Subject: FW: Planning application-F/24/96768

Proposed building entrance and living green wall- Design and access statement part 2

Roof Terrace and Green roof on proposed social pod

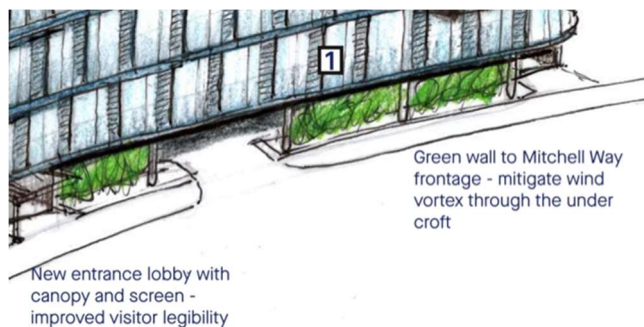
The design for the new entrance lobby should be mindful of what is proposed for the green wall as the green wall abuts the new entrance and needs to create a unified elevation. The access statement mentions the benefit of the living green wall mitigating the wind vortex through the undercroft and whilst this may be one function it will also provide an attractive frontage to the building in place of the existing hedge that has died and improve biodiversity in the area. Therefore the green wall will need to be robust and ensure plants are chosen that can withstand windy conditions. The wall is situated alongside a road and screens the undercroft car park so plants will need to tolerate pollution from cars and from the nearby airport.

Millbrook roundabout in Southampton is an example of a green wall where planting was chosen to help mitigate the pollution from car traffic in the area.

In addition to the structure and type of planting chosen consideration will also need to be given to watering and maintenance of the plants.

Proposed fourth floor plan

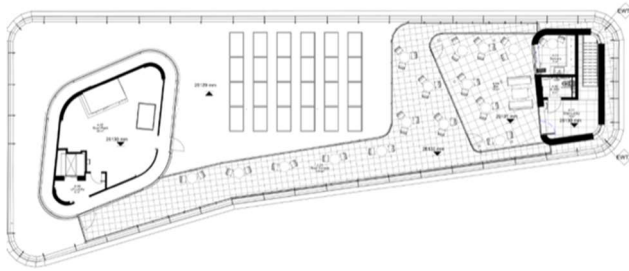
The roof terrace and pod have potential to be attractive spaces for users of the building with plenty of seating areas indicated on the roof floor plan

There is an indicated green strip of planting along the east side of the terrace but without more information it is difficult to understand how this will be achieved. There is no planting shown on the roof floor plan and in addition to the possible hedge shown on the sketch, planting on the terrace itself would help break up the areas of paving and create attractive spaces to sit in.

The green roof on the pod is a valuable environmental addition and together with the planting on the terrace will enhance the biodiversity of the site.
